40 WEST OAK CONDOMINIUM

Community Presentation

FEBRUARY 1, 2020

30 W. Oak Condominium Association Questions/Comments on 40 W. Oak FAR:

ZONING/ F.A.R.

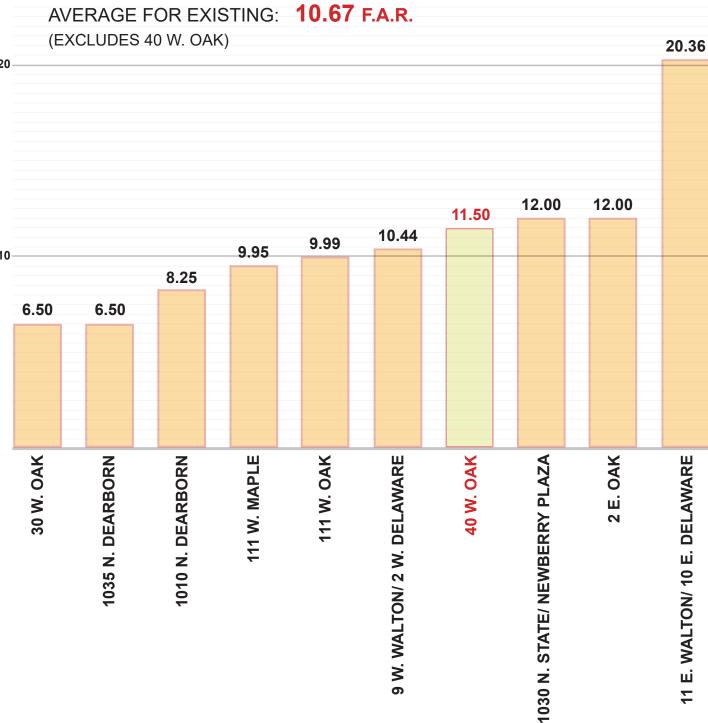
What is building FAR? Proposed FAR is inconsistent with neighborhood zoning and scale

- Request is for Planned Development with a base DX-7 designation and FAR bonus of 4.5 for total FAR of 11.5
- Site is a location designated by the City for Downtown Area expansion and high-intensity development
- FAR will be allocated between 2 subareas, with Barr Pavilion limited to current size
- Existing Barr floor area is 133,000sf; proposed new building floor area is 208,000sf (Total=341,000sf)
- Project will include open space in excess of City requirements
- Proposed FAR is consistent with the zoning of surroundings and neighborhood

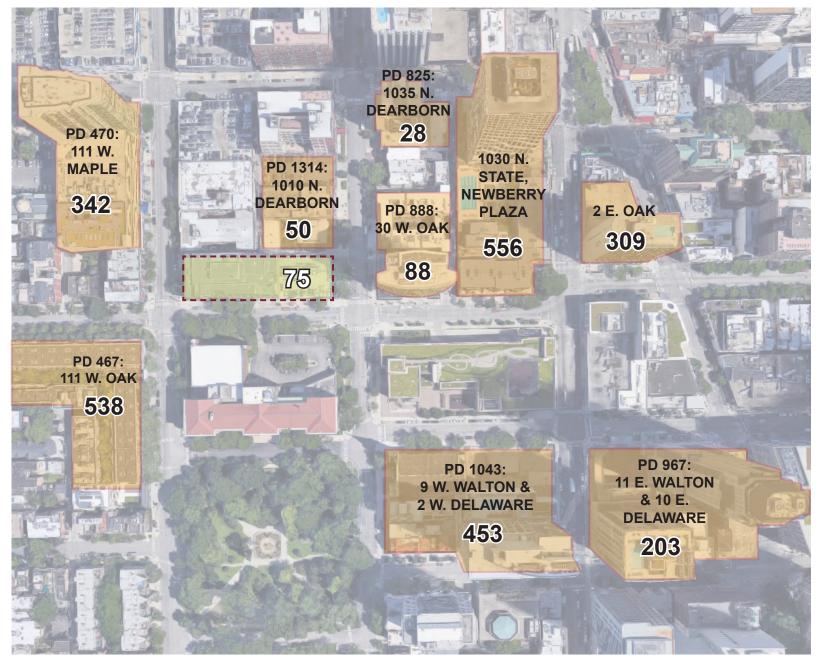
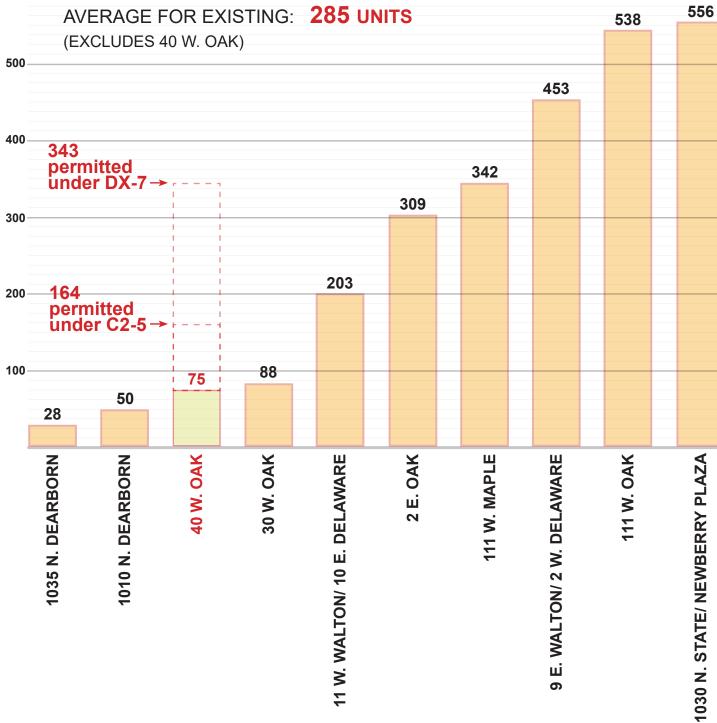
30 W. Oak Condominium Association Questions/Comments on 40 W. Oak Dwelling Unit Density: How many condo units? Proposed density is inconsistent with neighborhood zoning and scale

- Request is for approval of 75 dwelling units (formerly 90 units)
- Existing zoning allows residential use
- Existing zoning would allow 164 units on site; proposed base DX-7 zoning would allow 343 units on site
- City Affordable Requirements Ordinance permits payment of fee in lieu of inclusion of affordable units; developer will pay \$2.1 million into Affordable Housing Opportunity Fund in lieu of units
- Proposed residential density is consistent with zoning of surroundings and neighborhood

BUILDING HEIGHT

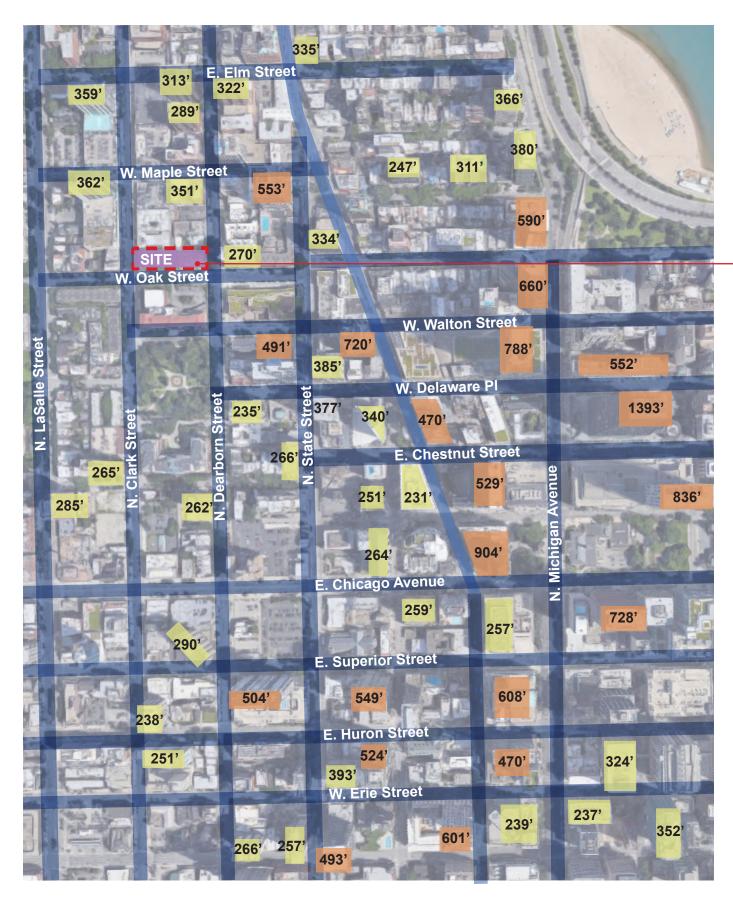
30 W. Oak Condominium Association Questions/Comments on 40 W. Oak Building Height: What is the building height? Proposed height is inconsistent with neighborhood zoning and scale

- Request is for building height of 466 feet (formerly 502 feet)
- Existing C2-5 zoning does not limit height; buildings in excess of 80 feet tall require Planned Development
- Barr Pavilion has height of approximately 106 feet
- Proposed building height is consistent with surroundings and neighborhood

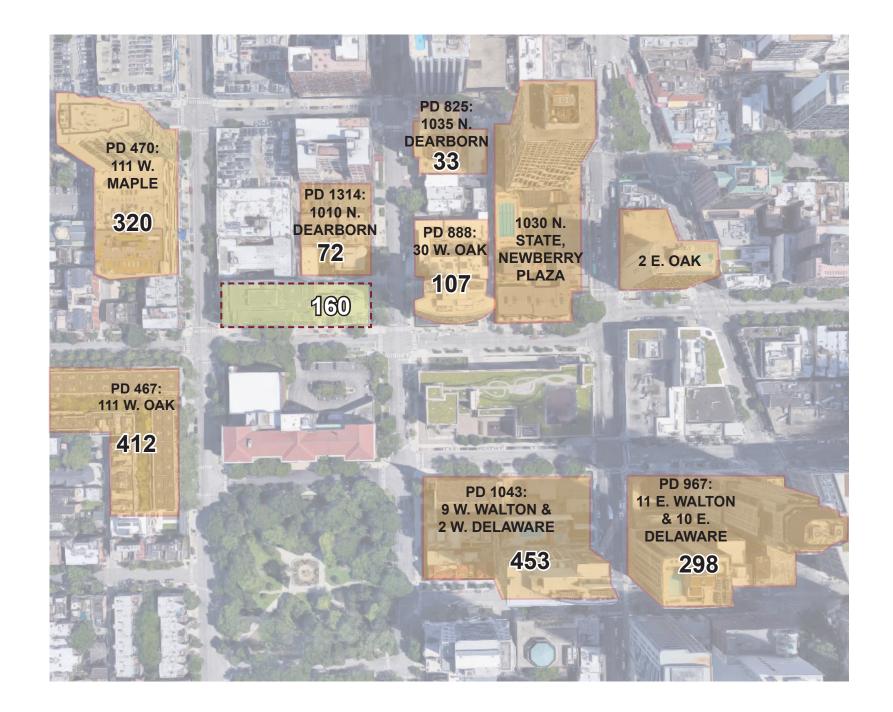
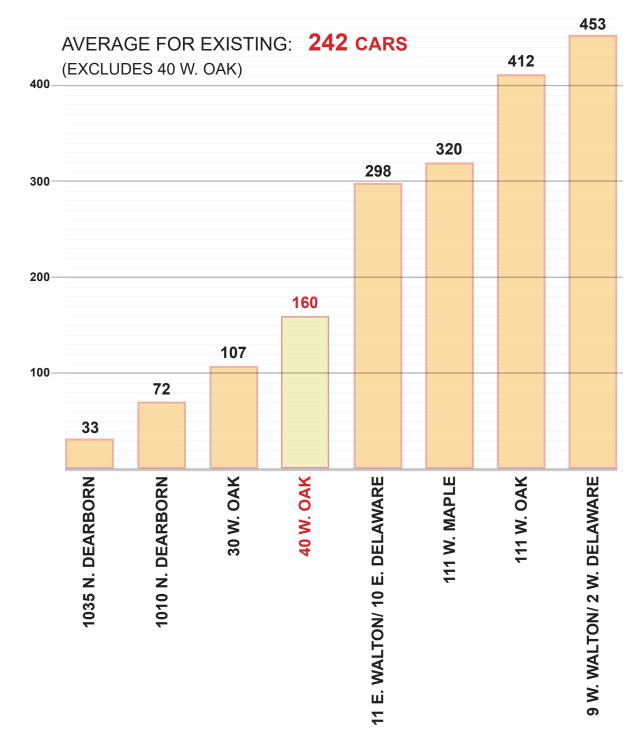
30 W. Oak Condominium Association Questions/Comments on 40 W. Oak Parking/Traffic:

How many parking spaces? Locations of site access? Proposed parking ratio is inappropriate; Must have interim parking for Barr Pavilion; Project traffic will overburden intersections and neighborhood; Alley cannot serve building

- Request is for 160 fully-enclosed parking spaces; site currently includes 70 parking spaces
- Proposed parking complies with requirements of existing C2-5 zoning

- Proposed parking will satisfy demand from 75 dwelling units and the Barr Pavilion; no parking will be provided for outside valet operators
- 50 parking spaces will be dedicated for use by the Barr Pavilion

- Residential parking ratio will be 1.46 spaces per dwelling unit
- All loading and drop-off will occur within the site, and alley will not be changed
- Project will include reduction of driveway width on Dearborn Parkway

- Barr Pavilion will provide alternative parking and a shuttle bus service during project construction
- KLOA Inc. has prepared a traffic study showing that vehicular access, parking, and loading will operate effectively, that area intersections operate at typical levels of service, and that project will have negligible incremental impact on area traffic and congestion
